Review of North/West Battery Park City Project Suggested Alignment Alternative

The North/West Battery Park City Resiliency (“N/WBPCR”) Project design team has received, among the comments submitted by the public in response to the Project alignment preferred by BPCA and the design team and designated in the 30% Project design, a concept for an alignment alternative within Reaches 3 and 4 of the Project Area (the “Suggested Alternative”). Based upon the design team’s consideration and analysis of alignment alternatives, including the potential viability of the Suggested Alternative, it has concluded that the Suggested Alternative poses challenges and creates conditions that run counter to the objectives of the N/WBPCR Project. In summary:

← 4 River Terrace New York

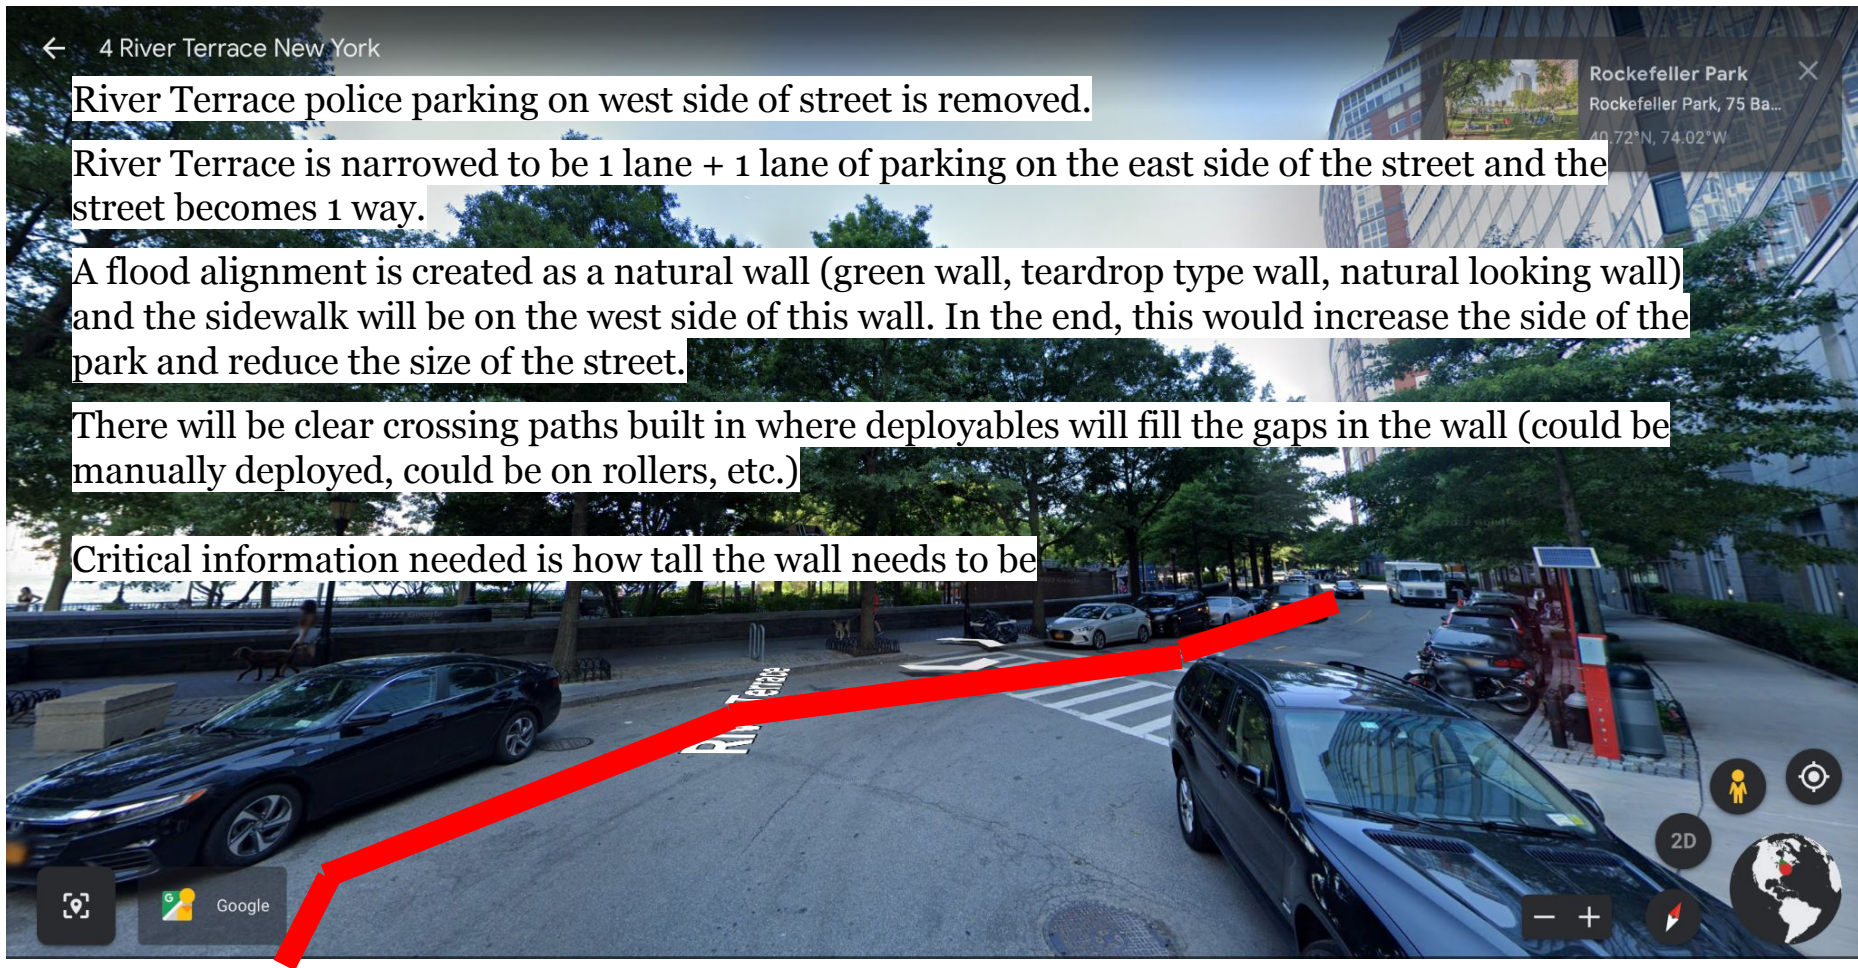
River Terrace police parking on west side of street is removed.

River Terrace is narrowed to be 1 lane + 1 lane of parking on the east side of the street and the street becomes 1 way.

A flood alignment is created as a natural wall (green wall, teardrop type wall, natural looking wall) and the sidewalk will be on the west side of this wall. In the end, this would increase the side of the park and reduce the size of the street.

There will be clear crossing paths built in where deployables will fill the gaps in the wall (could be manually deployed, could be on rollers, etc.)

Critical information needed is how tall the wall needs to be

← 6 River Terrace New York

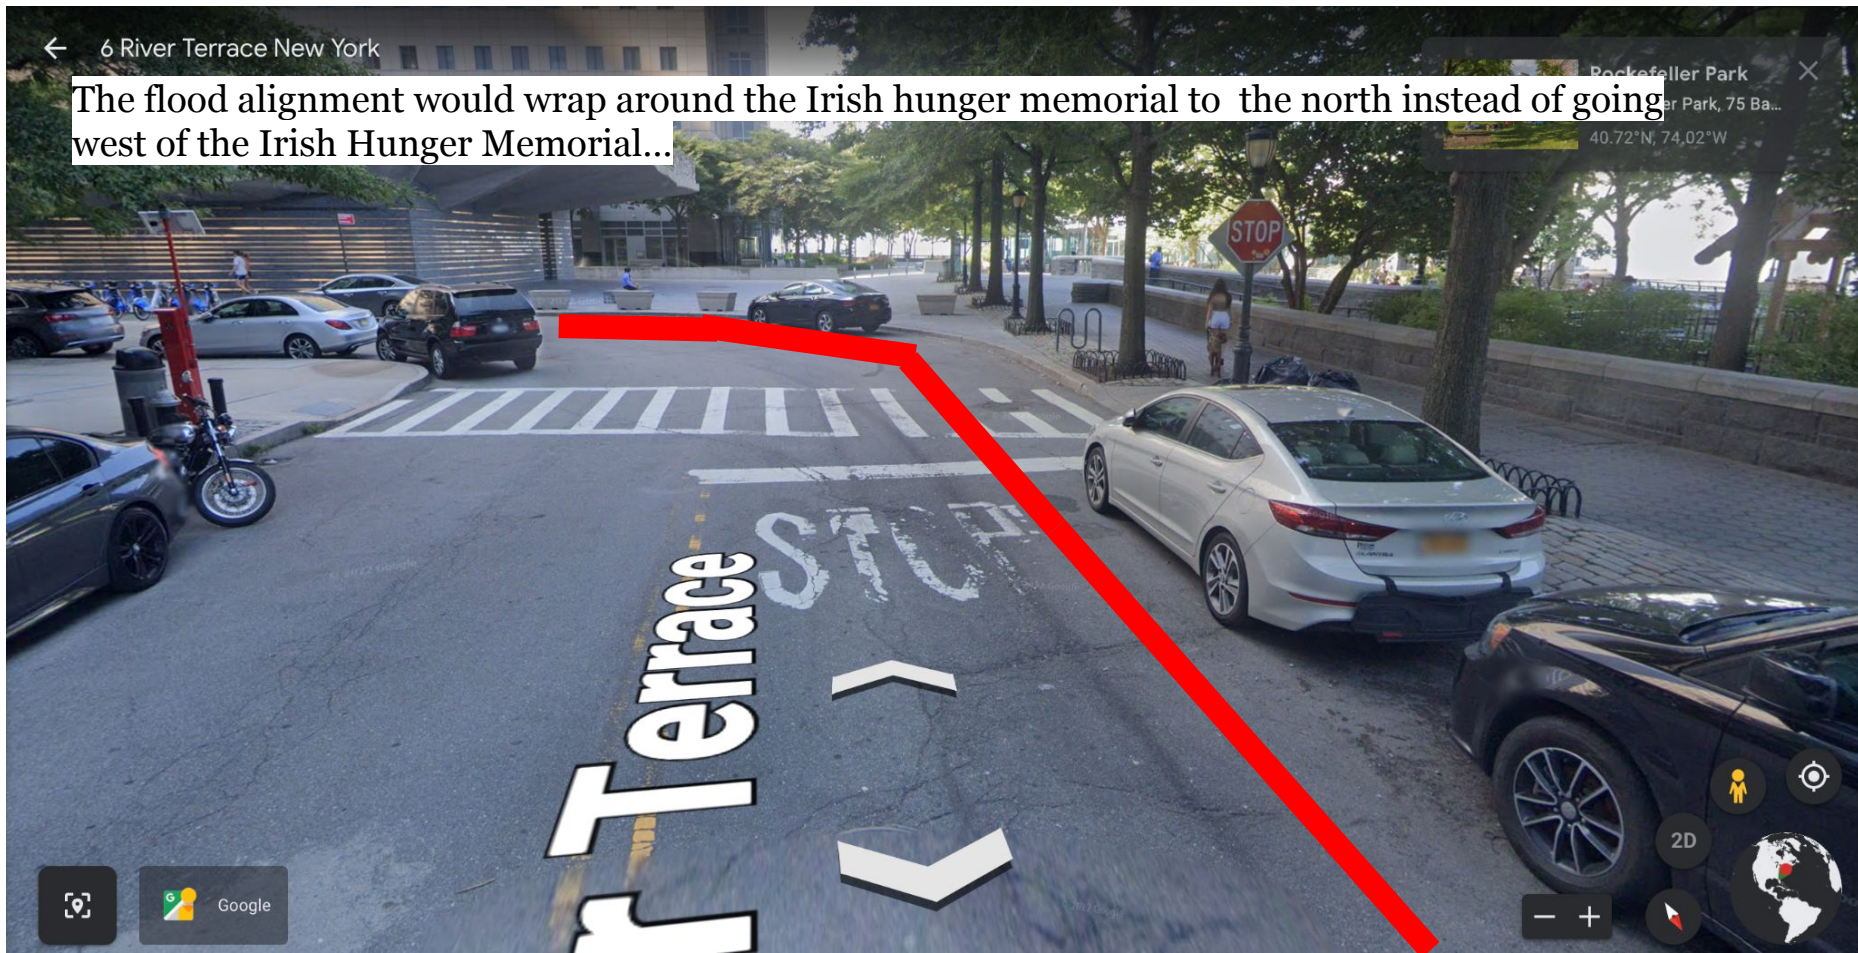
The flood alignment would wrap around the Irish hunger memorial to the north instead of going west of the Irish Hunger Memorial...

- **COSTS & CONSTRUCTION IMPACT OF ALTERNATIVE PROPOSAL:** The current alignment is approximately 150 feet in length across the west side of the Irish Hunger Memorial (“IHM”). The Suggested Alternative would require the length of the alignment to be approximately 600 feet, or four times longer than that contemplated by the current design, with an associated increase in capital cost and construction duration.

- **ALIGNMENT OPENINGS / CLOSURE GATES, SIGHT LINE IMPACTS & PEDESTRIAN FLOW:** The current alignment entails one opening (with a closure gate) located in front of the IHM on the west side, which minimizes sight line impacts to the users of the plaza while providing the required storm protection. The Suggested Alternative would require at least three (3) and as many as five (5) new openings (with closure gates) to break up contiguous walls along River Terrace, Vesey Street, and North End Avenue for public access. This would increase the project costs and restrict movement of pedestrian flow around and into the IHM.

- **AESTHETIC IMPACTS, GREENSPACE & CONNECTION TO PARK:** The impact of the current alignment was designed to minimize aesthetic impacts to public space and maintain much of the plaza in front of the IHM, while conforming to the existing wall elements on the upland side of the Lily Pond. The Suggested Alternative along River Terrace would entail a more significant disruption than the current alignment and would interrupt Citi Bike parking and/or restrict River Terrace Street width.

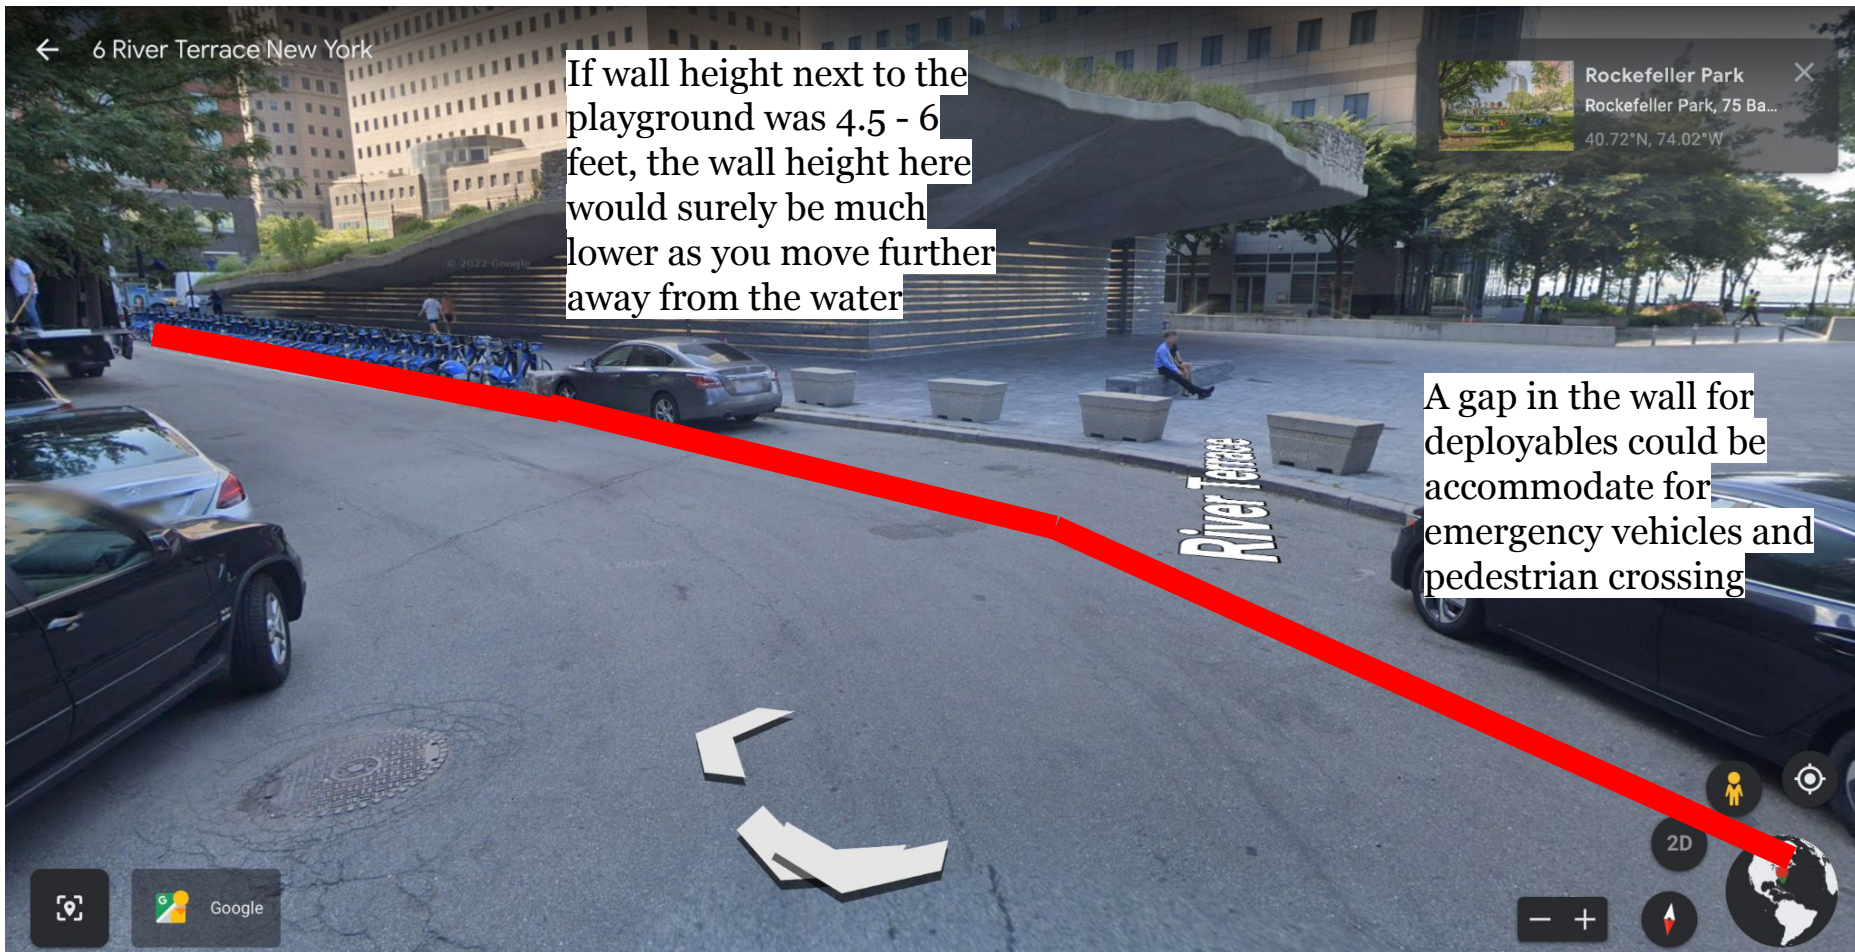
If wall height next to the playground was 4.5 - 6 feet, the wall height here would surely be much lower as you move further away from the water

A gap in the wall for deployables could be accommodated for emergency vehicles and pedestrian crossing

4 River Terrace New York

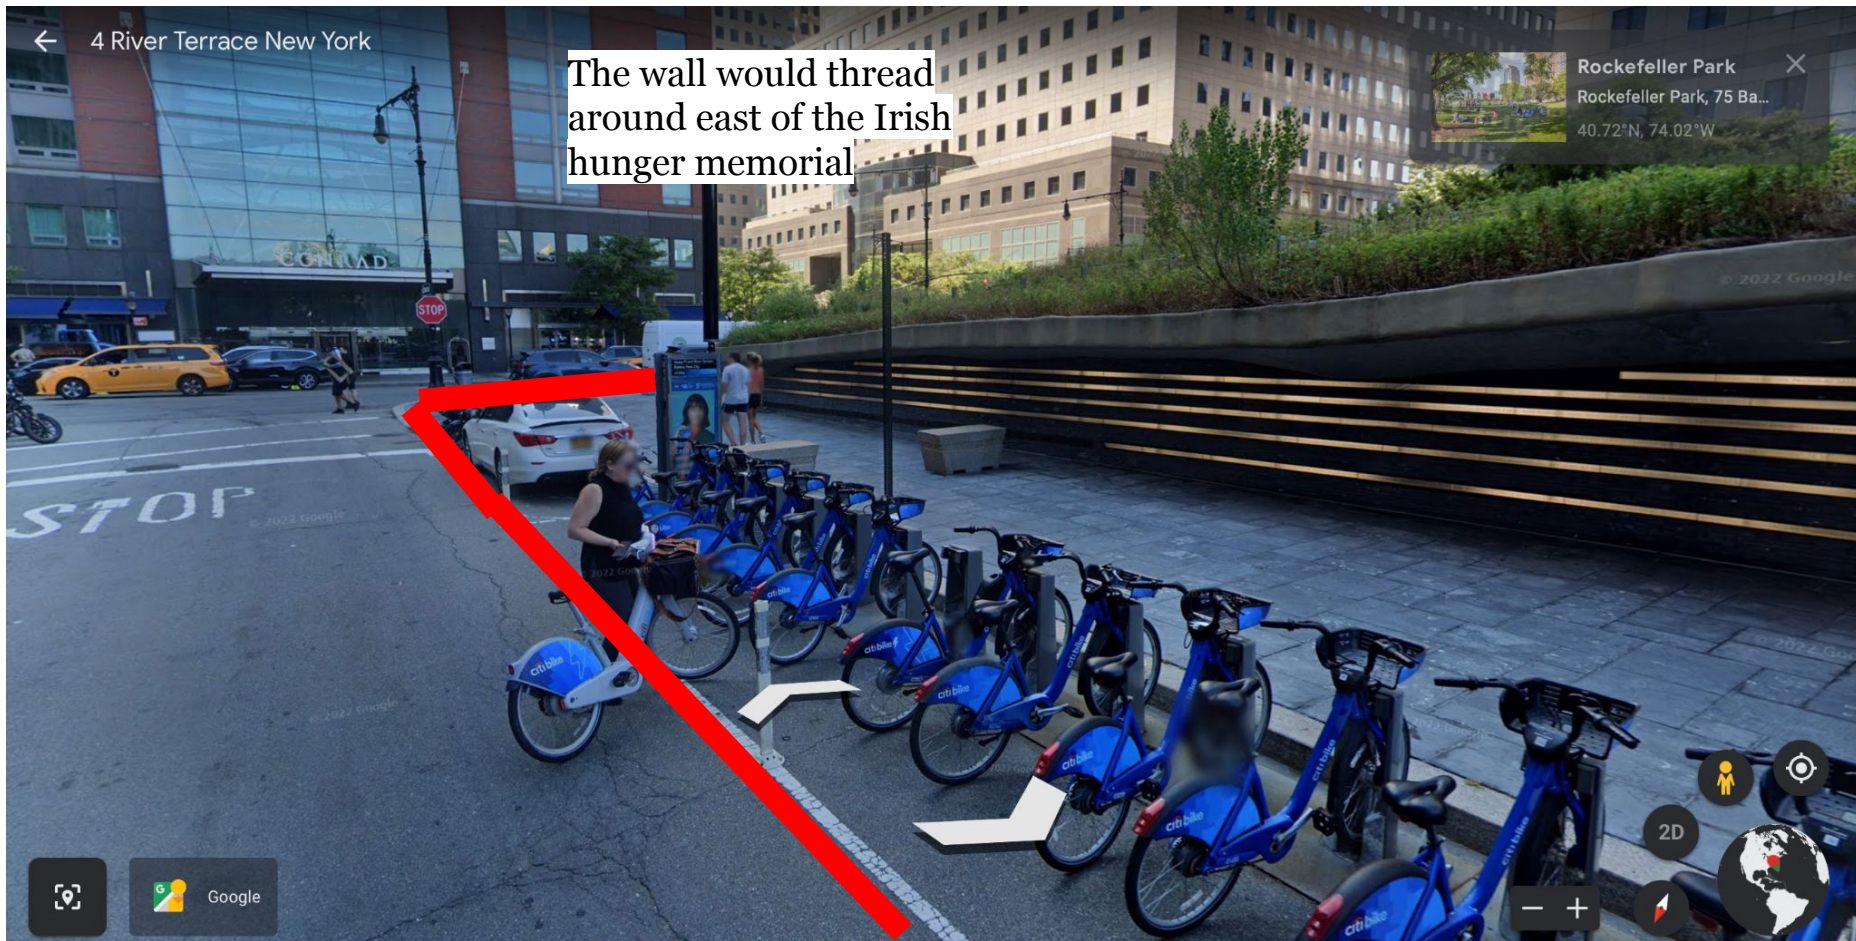
The wall would thread
around east of the Irish
hunger memorial

← 4 River Terrace New York

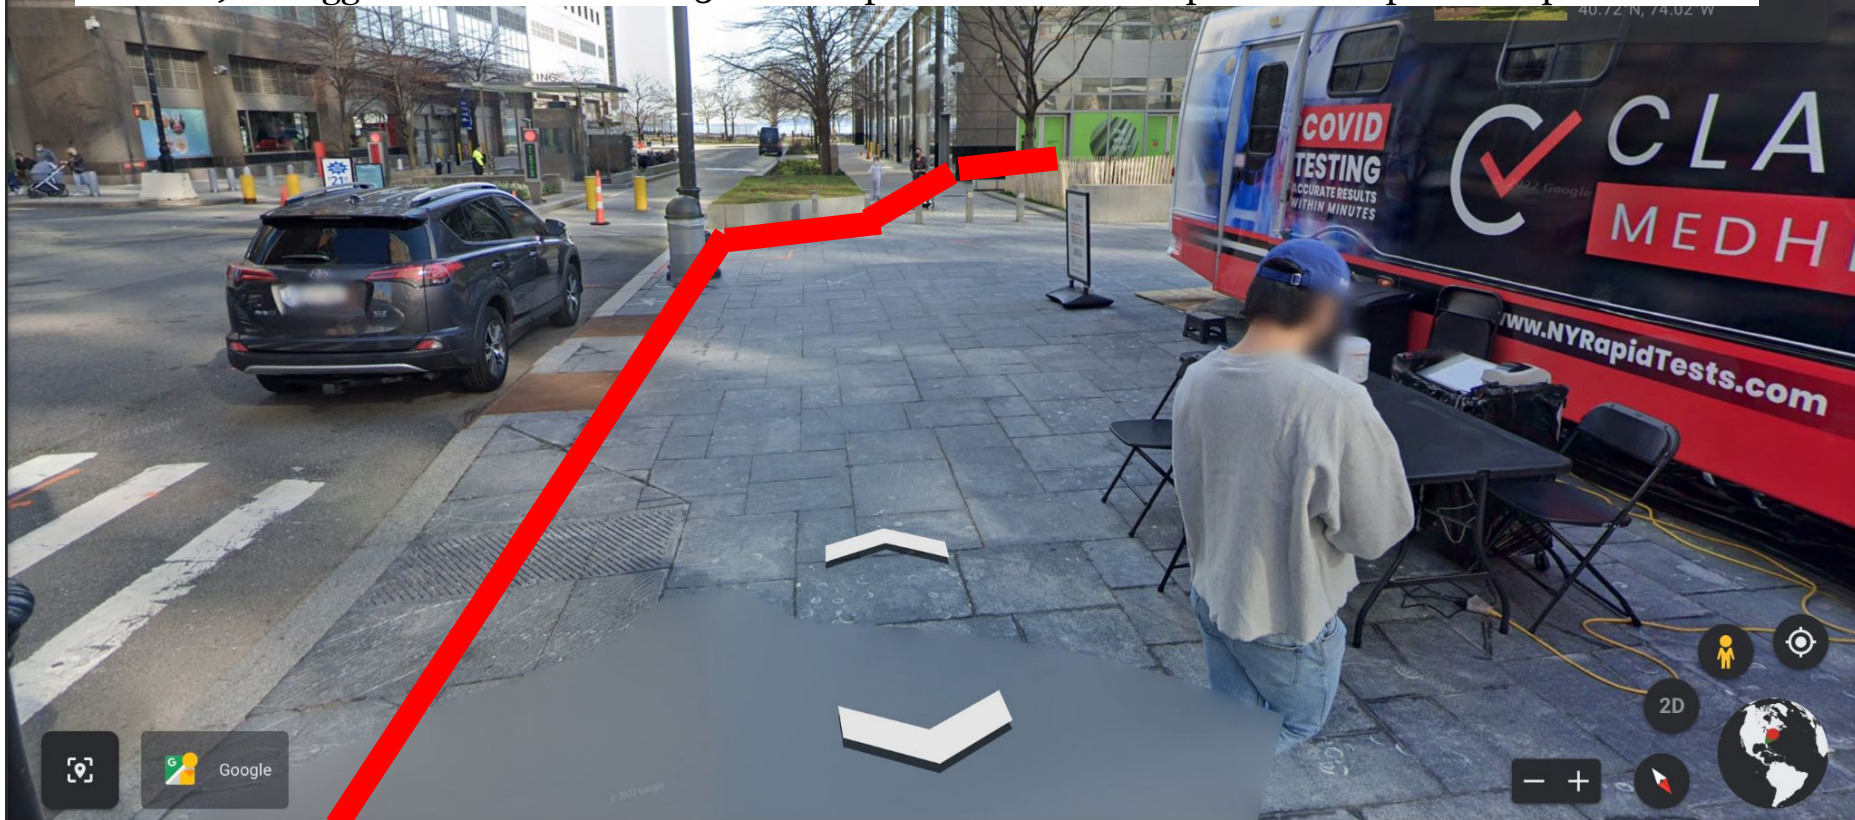
Continues wrapping around east of the Irish hunger memorial. The original designers of the memorial should be contacted and consulted

Flood alignment to be built into the side of the mercantile building (similar to the Jewish heritage museum) as suggested in the Feb 2023 workshop to minimize disruption to the park and public realm.
